Subject: Application for Amendment 3 to NUHOMS® EOS Certificate of Compliance No. 1042, Revision 4 (Docket 72-1042, CAC No. 001028, EPID: L-2021-LLA-0055) – Response to Request for Additional Information

This submittal provides responses to the Request for Additional Information (RAI) forwarded by the letter, Reference [1] above.

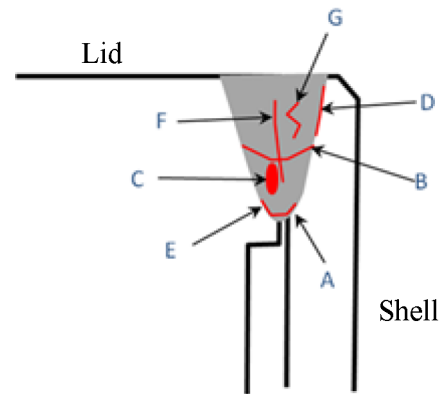
It is not clear whether the phased array UT examination, conducted from the external surface of the OTCP, will be able to detect and size weld flaws such as lack of fusion. For the multi-pass GTAW OTCP weld, phased array UT was shown to be an acceptable method for lack of fusion flaws when the examination was conducted from the outer diameter of the DSC shell (ML16159A227). The phased array UT application reviewed by the NRC in ML16159A227 was determined to be acceptable because the procedure was qualified using a blind performance demonstration in accordance with ASME B&PV Code Section V, Article 14, T-1424(b) with Intermediate Rigor that qualifies the equipment, procedure, and data analysis personnel for the detection and dimensioning of welding fabrication flaws. The previous demonstration does not appear to be applicable to the phased array UT described in the current application because the proposed phased array UT would be conducted from the outer surface of the OTCP rather than the external surface of the DSC shell. Further, the weld joint geometry of the single-pass HA-GTAW OTCP weld appears to be a narrow groove weld. Lack of fusion flaws in the single pass HA-GTAW OTCP weld are likely to be oriented perpendicular to the exterior surface of the OTCP. Because of this likely flaw orientation, it is not clear that the proposed phased array UT method from the exterior of the OTCP will be able to detect and adequately size a lack of fusion flaw in the single-pass HA-GTAW OTCP weld.

This information is needed to determine compliance with 10 CFR 72.236(l).

1. Even though the HA-GTAW weld is a narrow groove the as-welded cross-sectional dimensions are similar to multi-pass GTAW welds. Thus, the phased array automated ultrasonic testing (PA-AUT) procedure can be qualified for HA-GTAW weld and multi-pass GTAW welds.
